Subject: Core Operating Limits Report Revision - LDC 02001

Grand Gulf Nuclear Station
Unit 1
Docket No. 50-416
License No. NPF-29

GNRO-2002/00026

Grand Gulf Nuclear Station Core Operating Limits Report

Figure 4-4 APRM Flow-Biased Simulated Thermal Power – High Scram Allowable Values for Two-Loop Operation

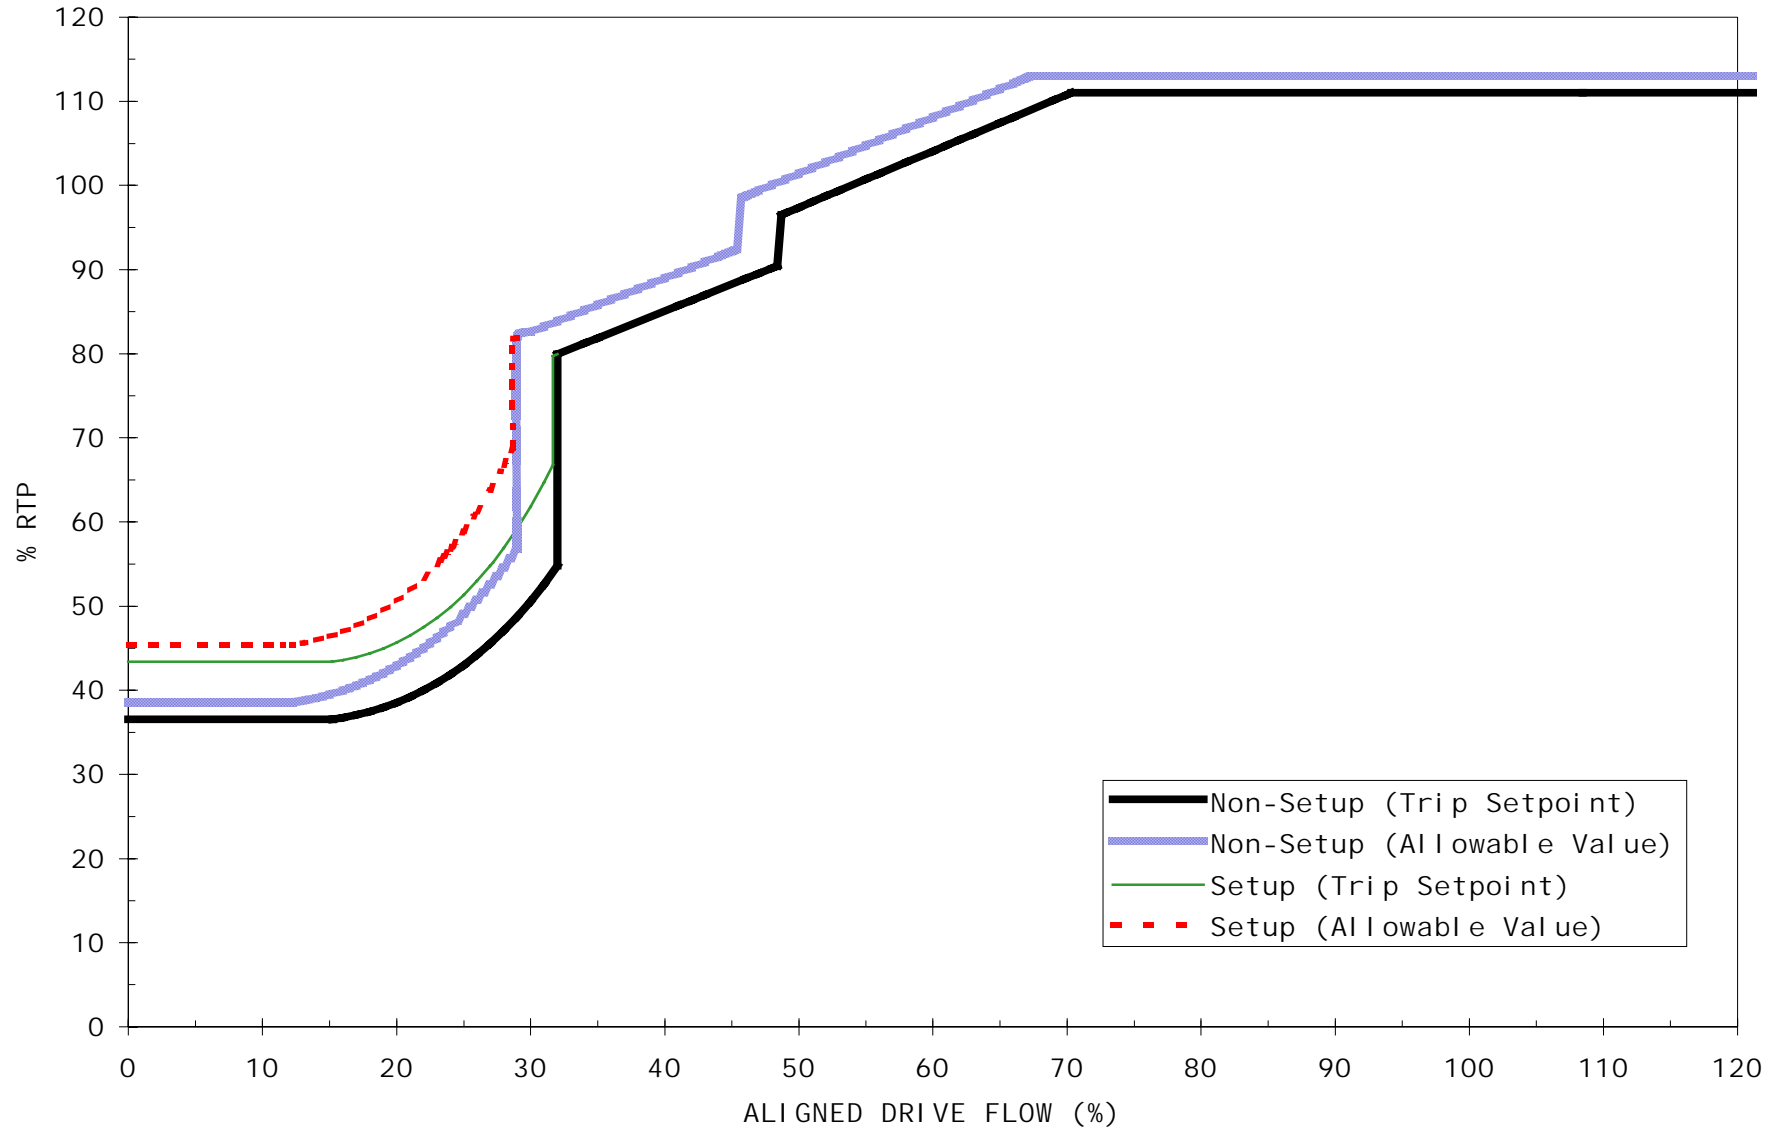
This change incorporates the Core Operating Limits Report (currently Engineering Standard MS-48.0) into Volume 1 of the Operating License Manual (OLM). The COLR is now a stand alone License Basis Document. Engineering Standard MS-48 is being cancelled. This change also resulted in a revision to COLR Figures 4-4 and 4-5 which were updated with additional information which was represented in Figures 3.3.1.1-1 and 3.3.1.1-2 located in Appendix 16B.1 of the Updated Final Safety Analysis Report. This added information was previously reviewed and approved via LDC 98037 which implemented Technical Specification Amendment 141.

This revision places the COLR in the same Operating License Manual binder as the Technical Specifications. Also, this change will require the COLR to be controlled and updated the same way other License Basis Documents are and will result in elimination of duplicate COLR curves currently represented in the Technical Requirements Manual and UFSAR. In the past these duplicate curves have created confusion and required extra effort to keep all of the curves up-to-date with one another. This change also resulted in a revision to Figures 4-4 and 4-5 which were updated with additional information which was previously represented in UFSAR/TRM Figures 3.3.1.1-1 and 3.3.1.1-2. The additional information added was previously reviewed and approved via LDC 98037 which implemented Technical Specification Amendment 141.
